**MAJOR PROJECT APPLICATION MP10_0105 AND DA609/2010 - RESIDENTIAL
 DEVELOPMENT AT 40 WALKER STREET, RHODES**

**EXHIBITION OF ENVIRONMENTAL ASSESSMENT FOR THE CONCEPT PLAN
AND 20 STOREY RESIDENTIAL DEVELOPMENT
40 WALKER STREET, RHODES**

Re: MP 10_0105 & DA 609/2010 Residential Development at 40 Walker Street Rhodes

**Re: Residential and Retail Development at Site 2A and 3A 40 Walker Street,
Rhodes (MP – 10-0105 and DA 609/2010)**

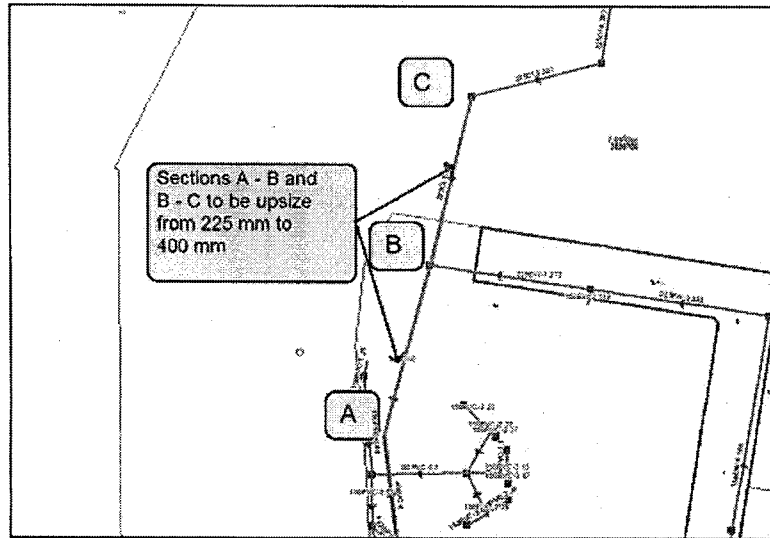
The existing drinking water network has sufficient capacity to service the proposed development. The developer will need to connect to the 300 mm main available on the western side of Shoreline Drive or the 250 mm main available on the western side of Walker Street.

According to engineering analysis methods consistent with the Sewerage Code of Australia (Sydney Water Edition WSA 02-2002), the minimum sized wastewater main required is a 400 mm main. The approximate location can be seen on the plan below.
